**From:** Tiffany, Bruce  
**Sent:** Friday, May 19, 2006 9:48 AM  
**To:** Renaud, Rick  
**Subject:** RE: Sample Sites at KCIA

**From:** Tiffany, Bruce  
**Sent:** Wednesday, May 17, 2006 12:14 PM  
**To:** Renaud, Rick  
**Subject:** Sample Sites at KCIA

**From:** Tiffany, Bruce  
**Sent:** Wednesday, May 17, 2006 12:14 PM  
**To:** Renaud, Rick  
**Subject:** Sample Sites at KCIA  
**Attachments:** BT\_Draft-KCIA-Sample\_Sites.pdf

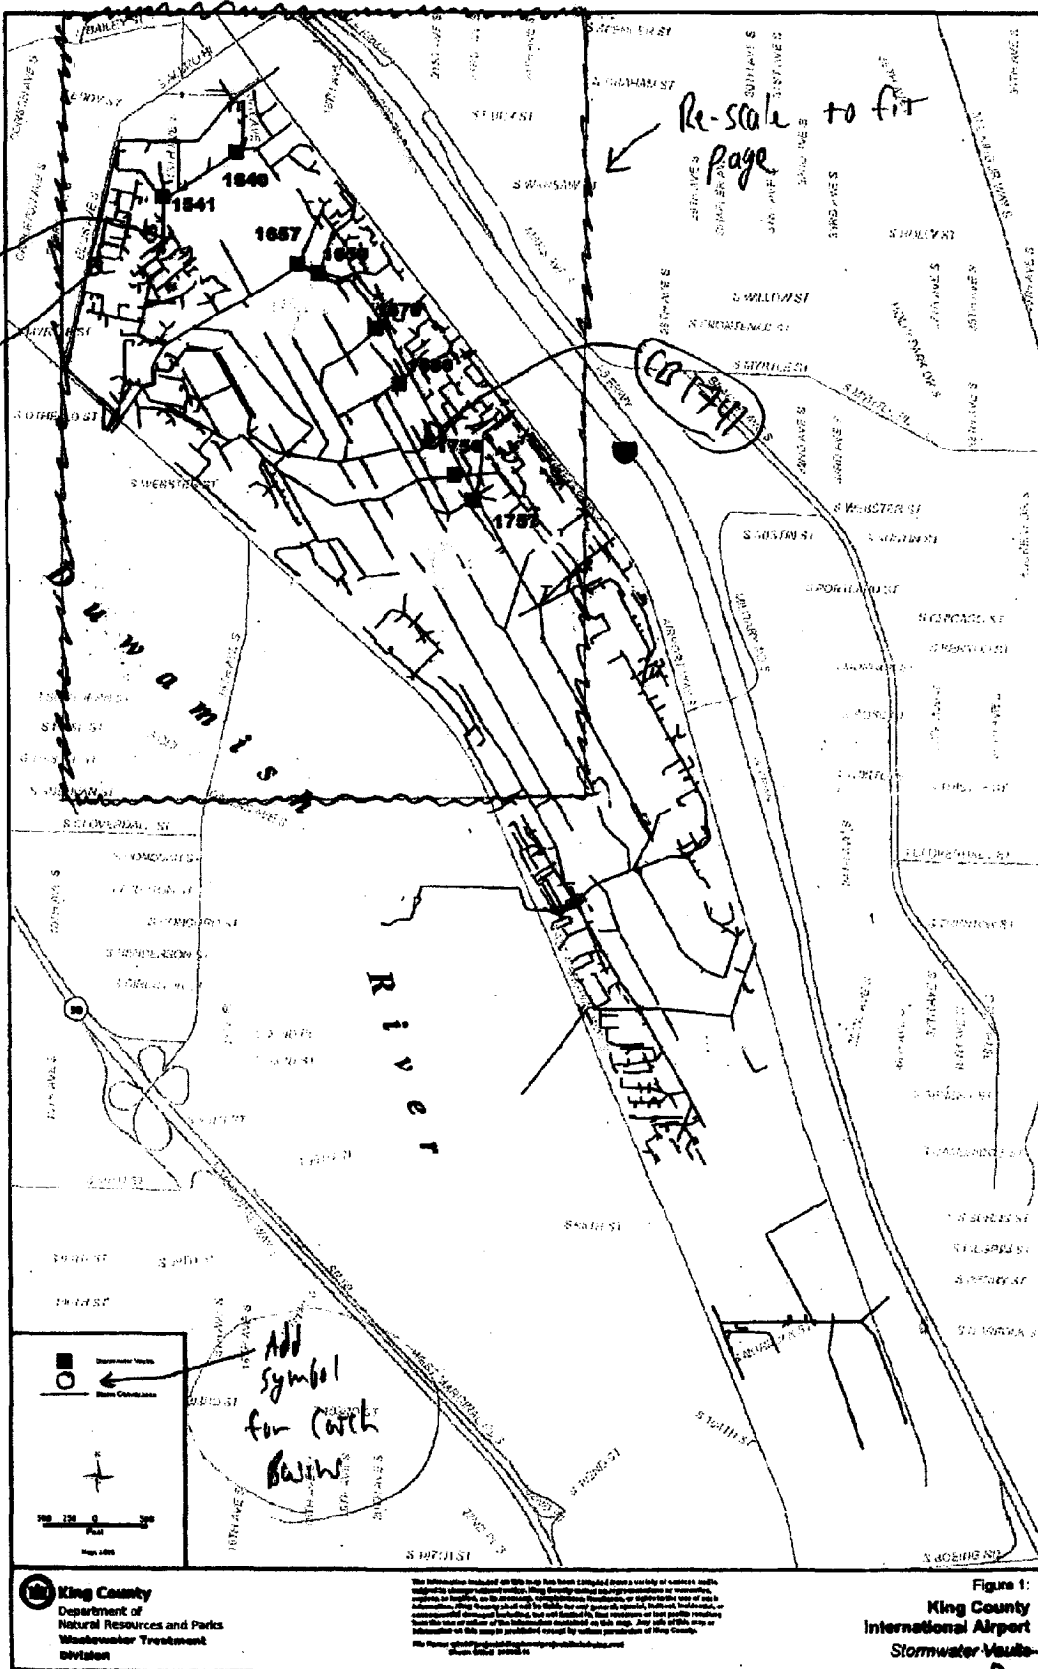
Looking at the locations of the stormwater vaults, it appears to me that we should sample a couple of catch basins to ensure that we have complete coverage. I think we should sample the following catch basins:

- CB1741 (This captures the line that drains the aircraft parking area and is located between Vaults 1680 and 1756)
- CB1554 and CB1575 (Provides coverage in the northwestern portion of KCIA)

Please see the attached file that shows the proposed sample locations. I have also added some notations for our GIS/graphics person. Please let me know your thoughts on adding these sample locations.

ok to include 1741. The others discharge into the city system or are on the Boeing lease.
